Field Engineering Bulletin
071828310 October 31, 2007

Trinix Broadlinx 2.4.2 Upgrade

Figure 1. 1024 x 1024 system.

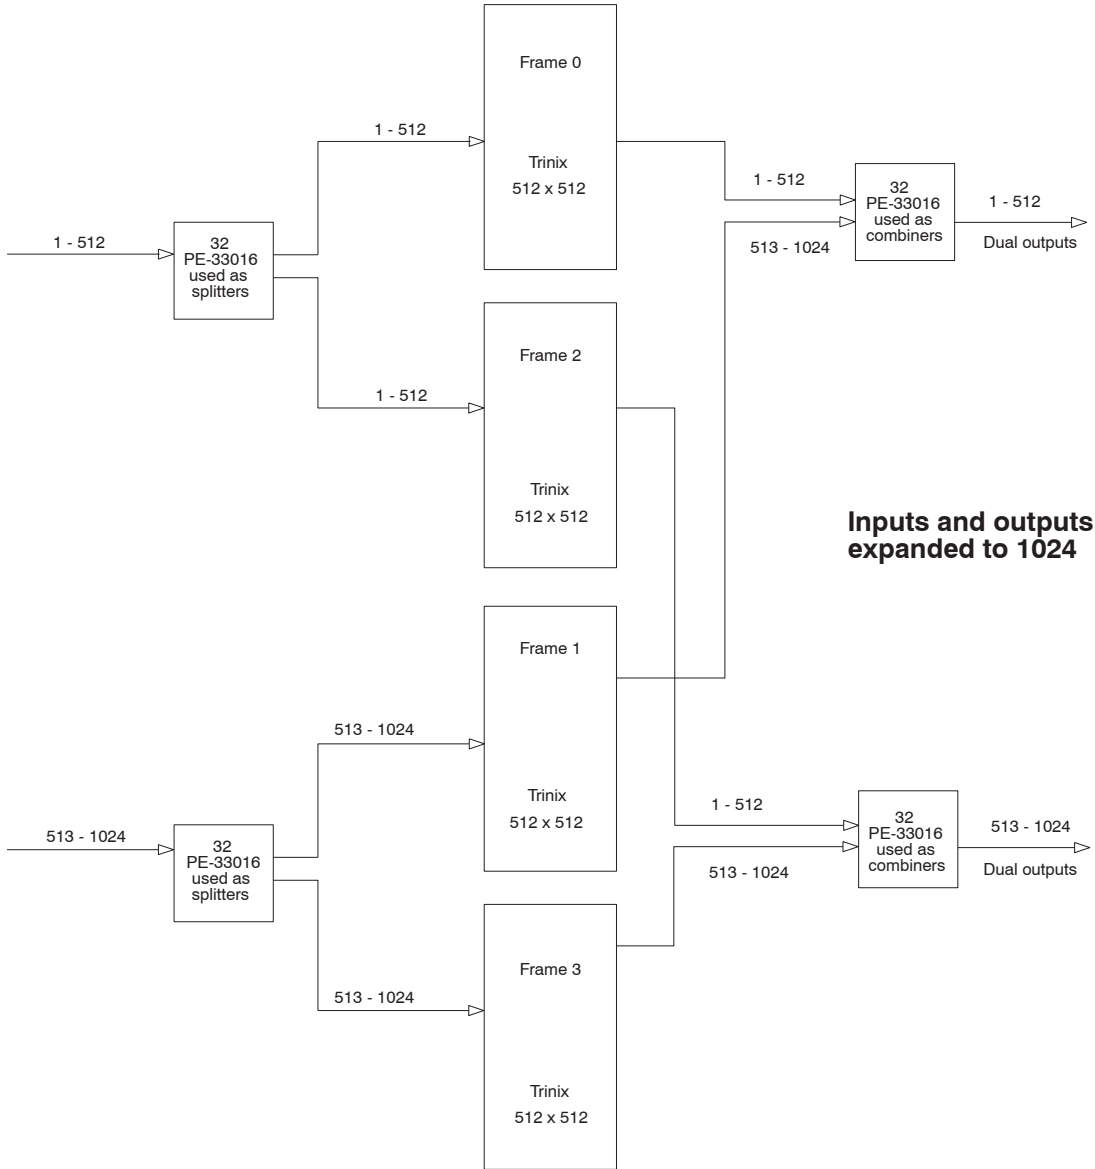
- b. The incorrect descriptions were shown in a series of block diagrams in Section 2, ("Planning Guide") under the heading "Duplication and Expansion - Expanded Systems." The errors are in the following four figures:

"1024 x 1024 system"

Each of these figures illustrate a series of 512 x 512 chassis in expanded systems, but the frame numbers shown are out of sequence. For example, the figure showing a "1024 x 1024 system" shows frame numbers reading (from top to bottom) "Frame 0," "Frame 1," "Frame 2," and "Frame 3;" whereas the correct sequence is Frame 0, 2, 1, and 3.

Corrected versions of these four figures are included with this document, starting on page 13.

As explained on page 4, the following four drawings are replacements for the corresponding drawings published in version 071827606 (and prior) of the Trinix Planning and Installation manual.

Figure 2. 1024 x 2048 system.

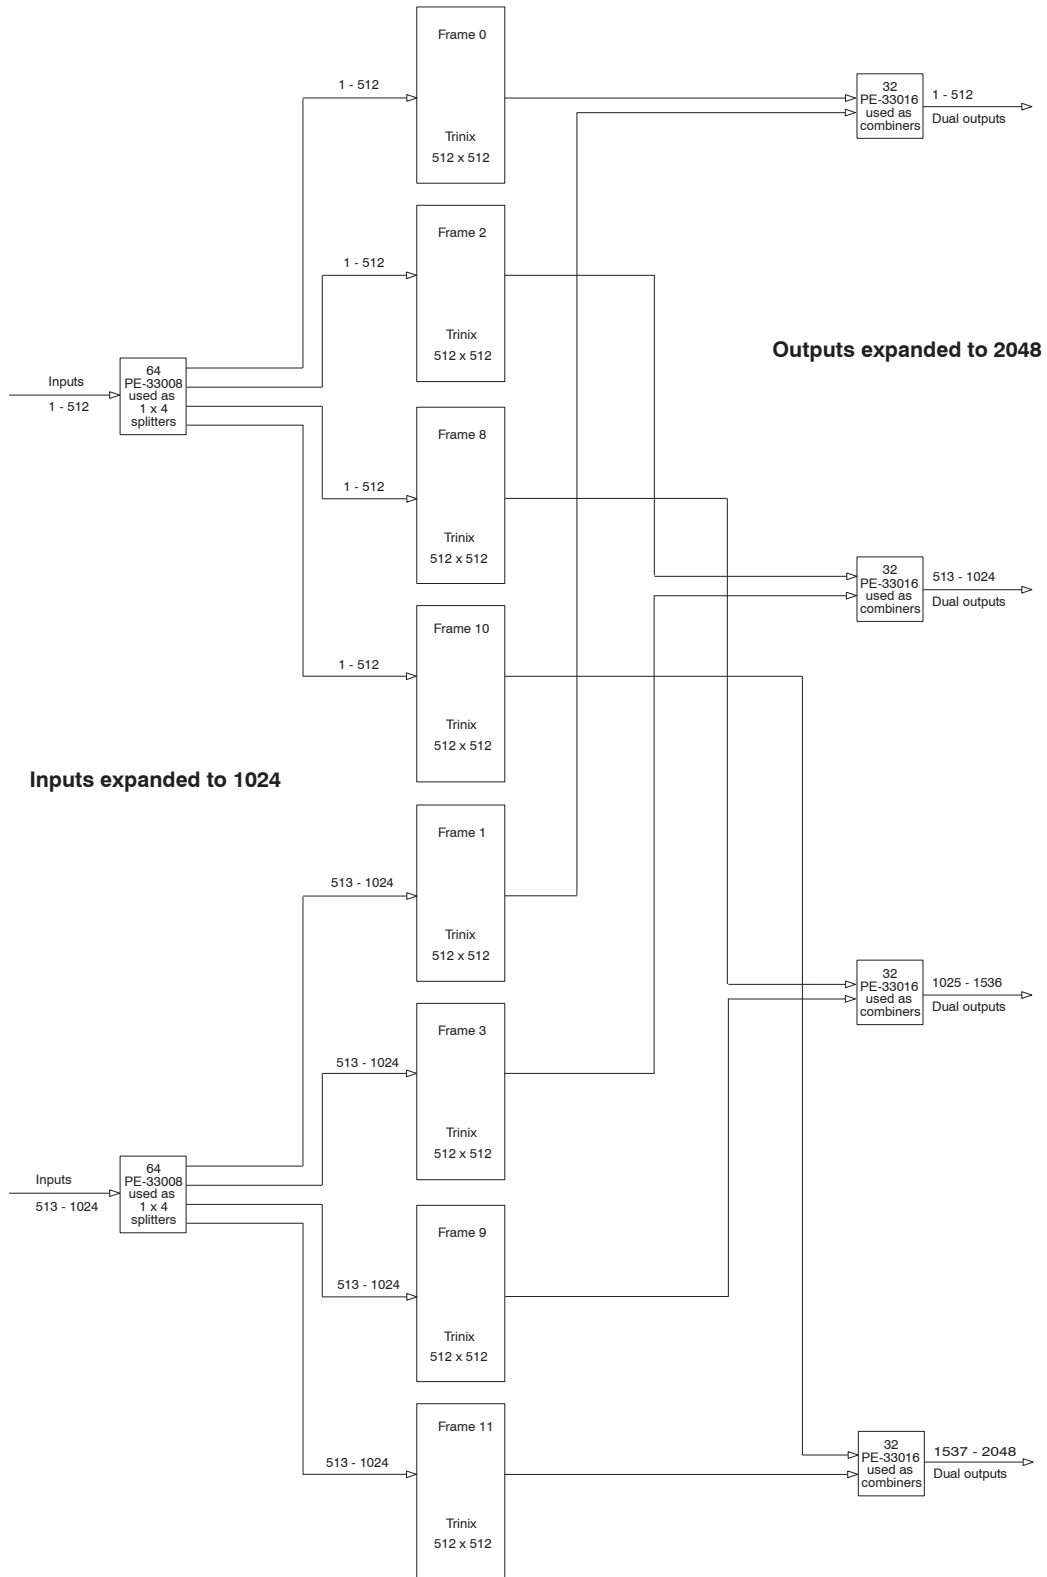
"1024 x 2048 system"

Figure 3. 2048 x 1024 system.

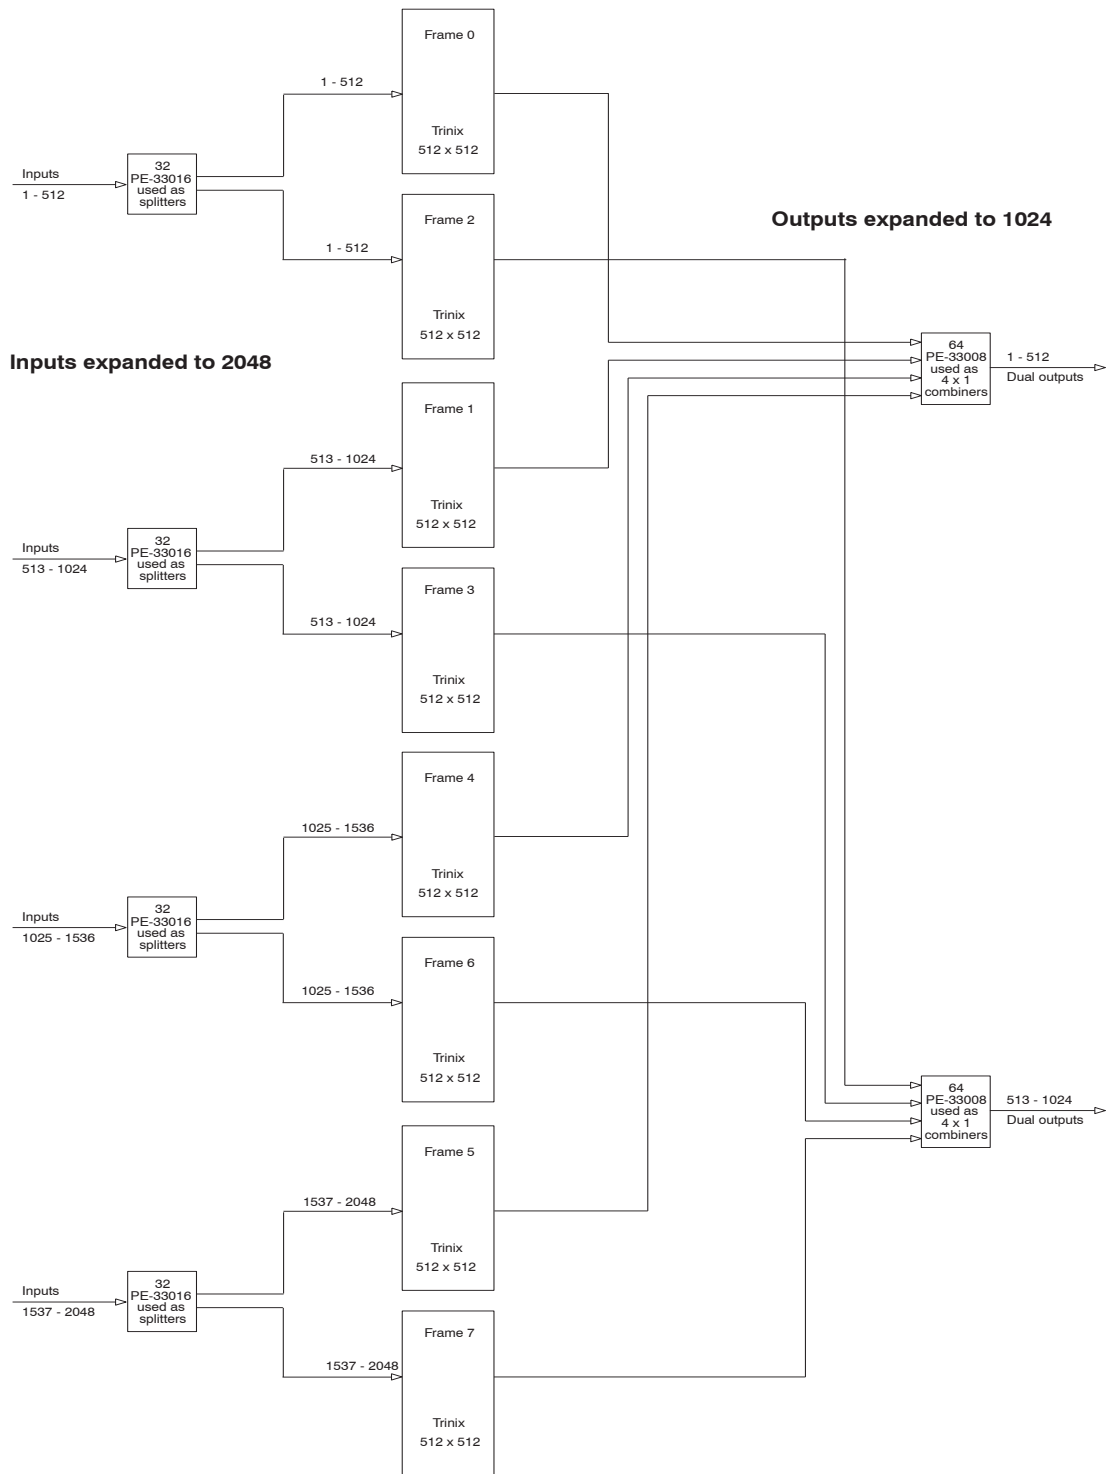
"2048 x 1024 system"

Figure 4. 2048 x 2048 system.

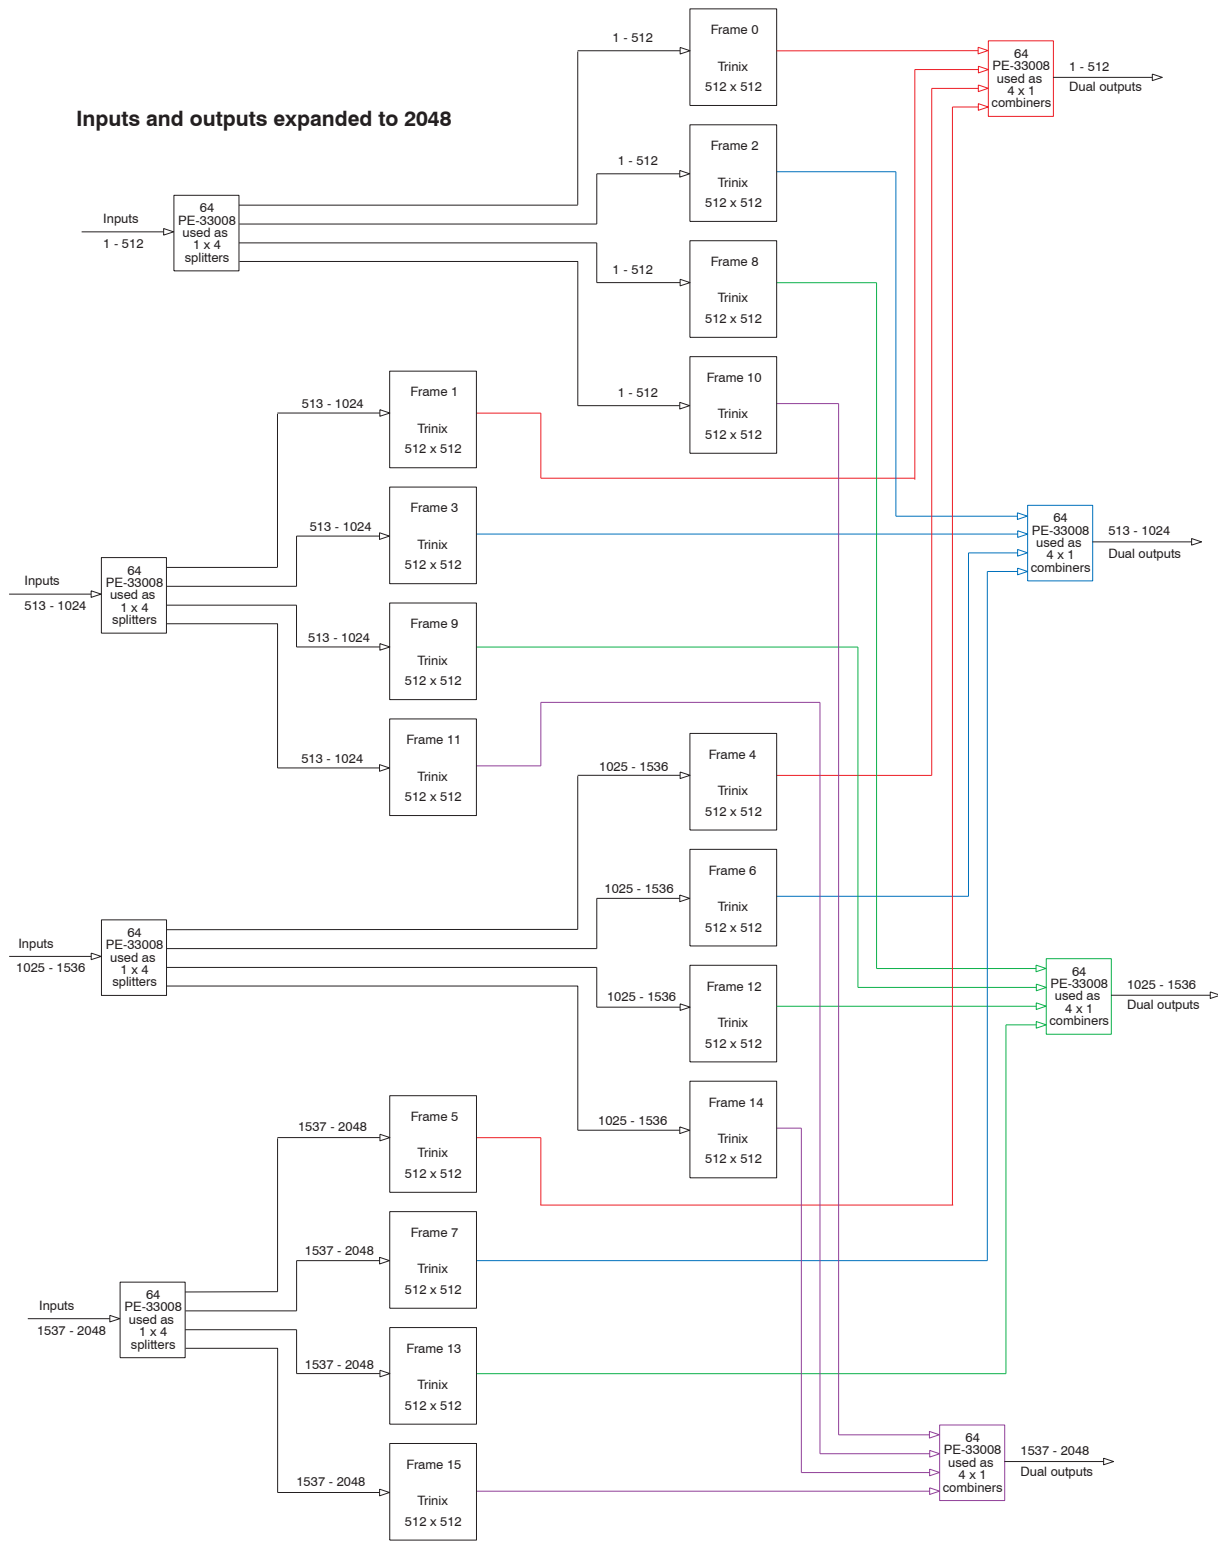
"2048 x 2048 system"
